UNITED STATES PATENT AND TRADEMARK OFFICE

APPLICATION NO.	FILING DATE	FIRST NAMED INVENTOR	ATTORNEY DOCKET NO.	CONFIRMATION NO.
09/284,109	04/07/1999	OLEG STOLZ	STOLZ(PCT)	1902

Office Action Summary

DETAILED ACTION

FIG. 1

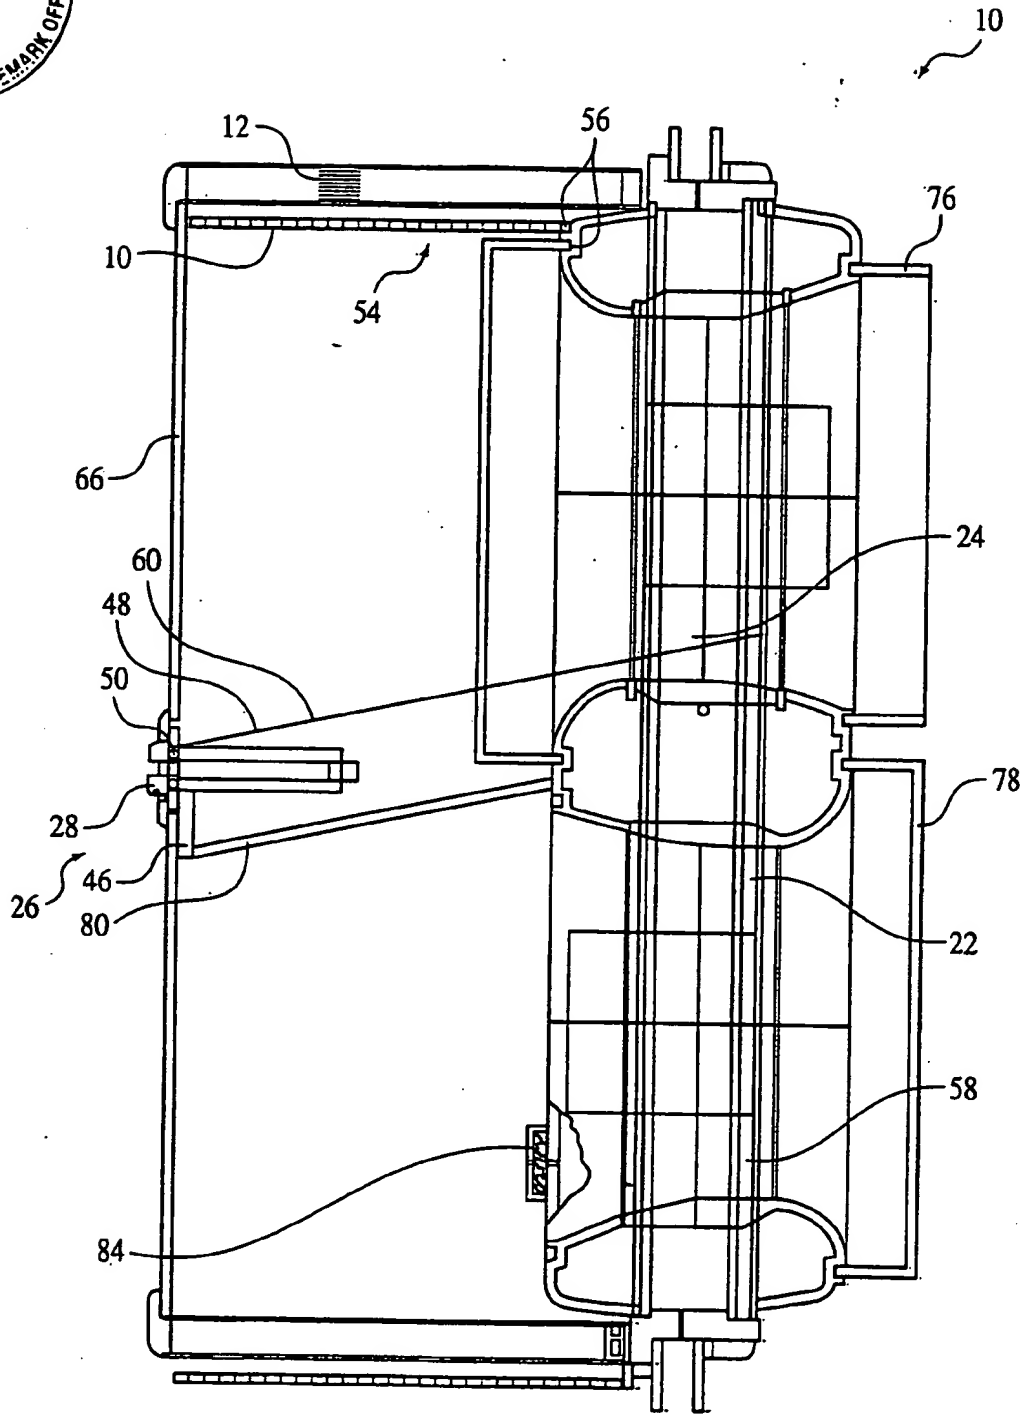
6. The replacement drawings were received on October 12, 2004. These drawings are hereby disapproved because they contain new matter. More particularly, the originally filed disclosure and drawings do not appear to support the particular correspondence between the various elements depicted in the drawings and the element nomenclature in the claims and in the specification via the newly assigned reference characters.

Not
approved.
ALC
4-29-05

FIG. 2

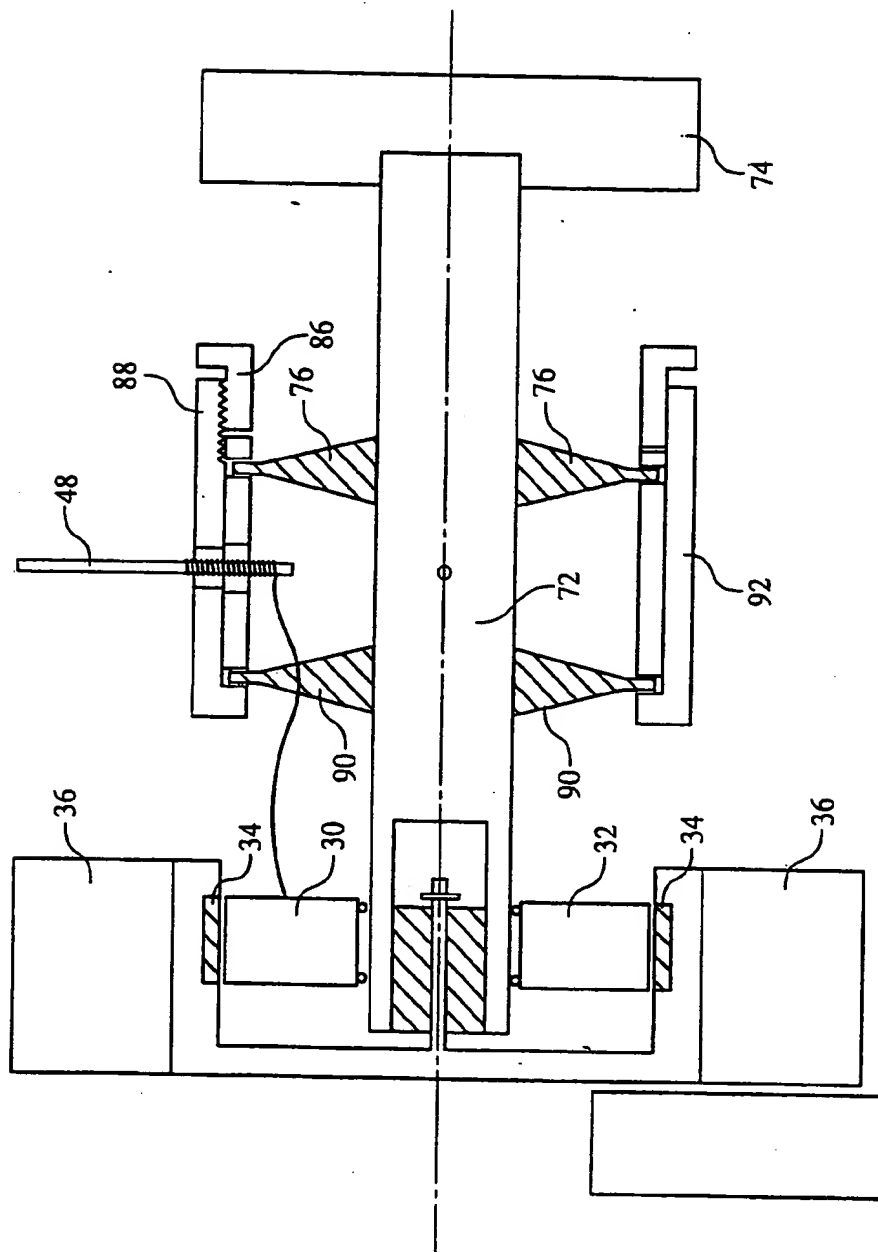
not
approved:
LVC
4-29-05

FIG. 3

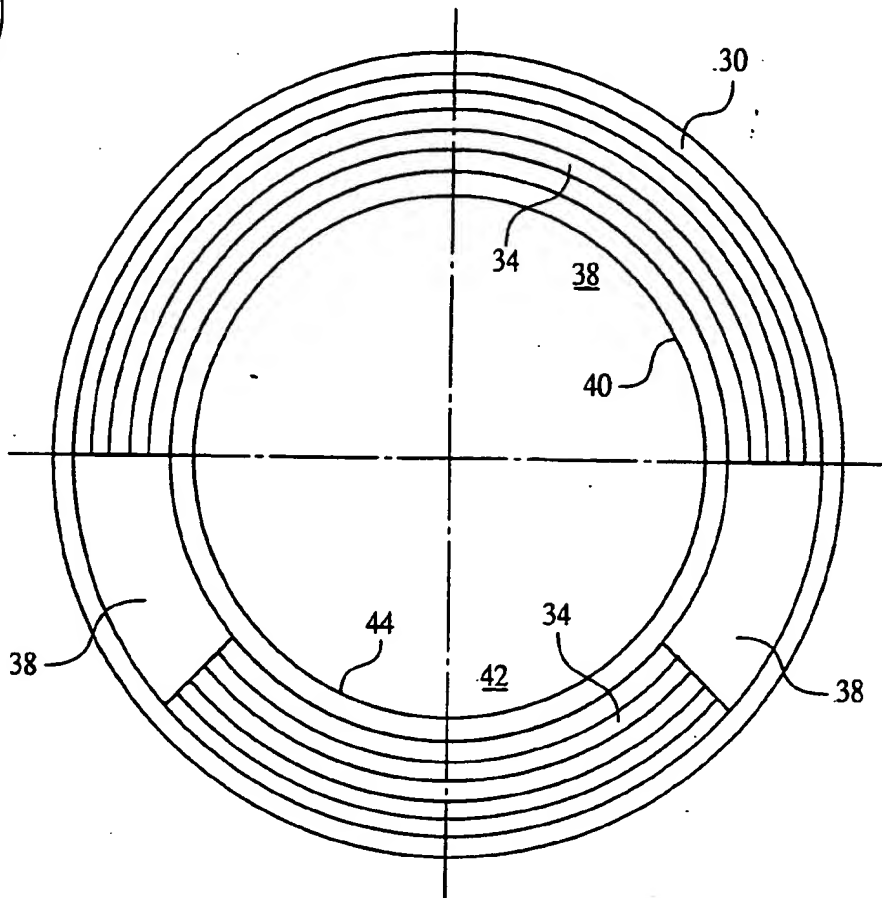
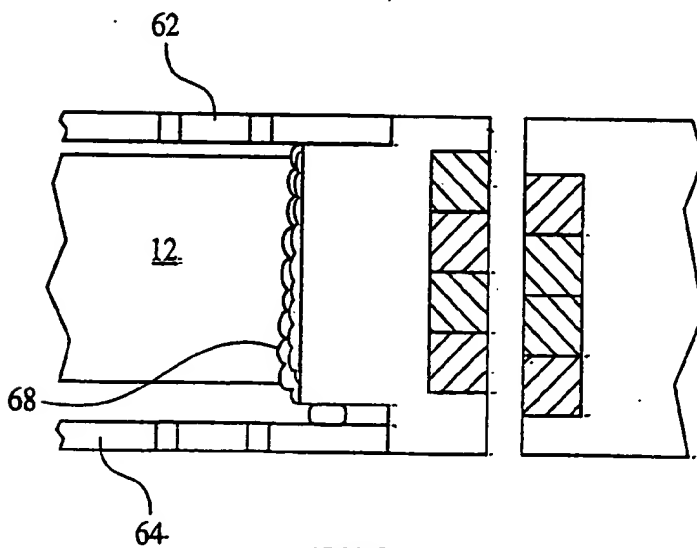
Not
approved.
LVC
4-29-05

FIG. 5

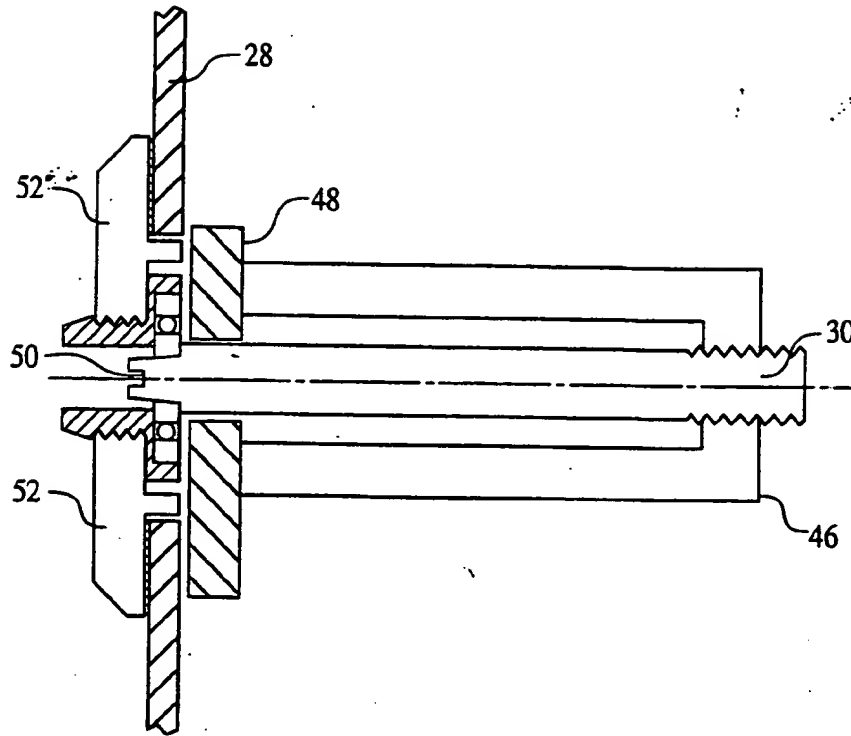
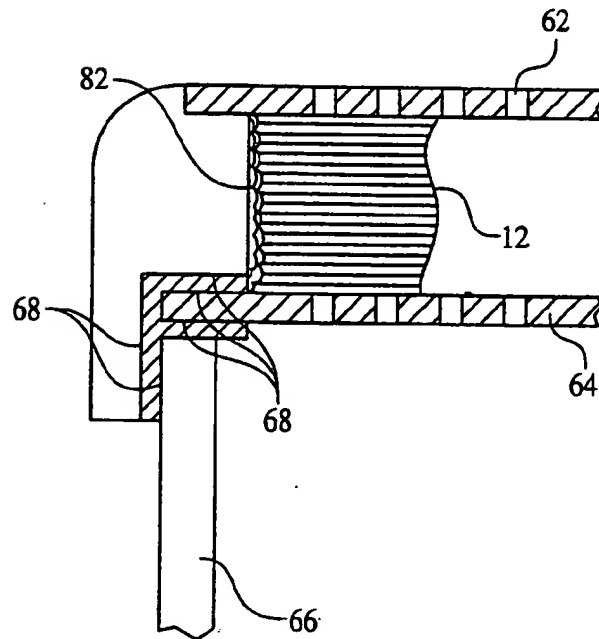
not
approved.
FVC
4-29-05
